KRISTENNA CHASE, PRESERVATION PLANNER SARAH WHITE. PLANNER & PRESERVATION PLANNER Case #: HPC 2018.037 **Date**: May 15, 2018

### PRESERVATION STAFF REPORT

Site: 14 Flint Street

Petition: Keith Fallon, 14 Flint LLC, Applicant, seeks permission from the Somerville Historic Preservation Commission (HPC) to add decks to the east side rear addition and replace two windows with two doors.

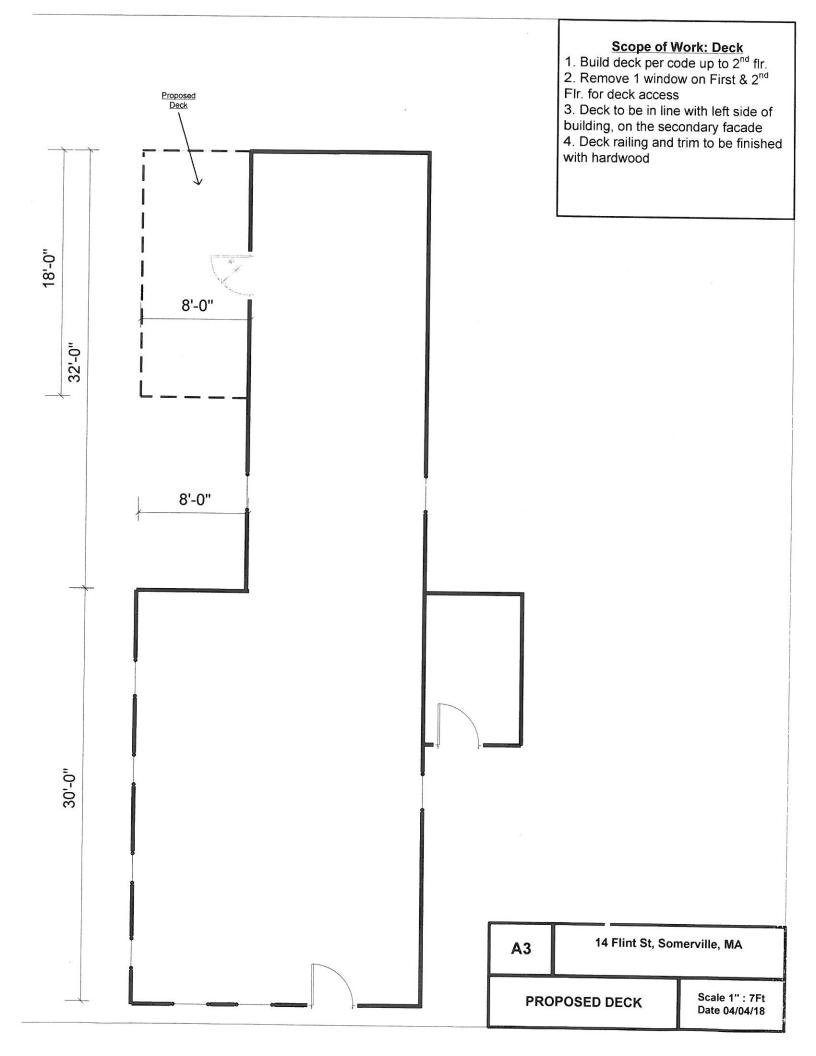
<u>Staff Findings</u> Staff finds that the proposed porches do not meet the HPC Guidelines. The size and location of the porches are not traditional. Side or rear porches and piazzas may span the width of a building or fit into the inner corner between the main portion of the building and an ell. A humble home, such as this from circa 1857-58 would not have had porches well above the ground level.

See the photos below with approximate locations indicated of the proposed alterations and a photo of another building which has a two-story porch on a slope added to the rear ell visible from the street.

Based on the information provided and an assessment of the proposal against the Somerville LHD guidelines, Staff recommends denying a Certificate of Appropriateness to add a porch at the far end of the building on two stories, and replacing two windows with two doors. Staff recommends that the Commission consider granting A Certificate of Appropriateness for a covered two-story porch located on the interior corner of the building with shorter dimensions and an entry door going into the main block of the building. A Certificate of Non-Applicability may be issued for repairs in-kind.
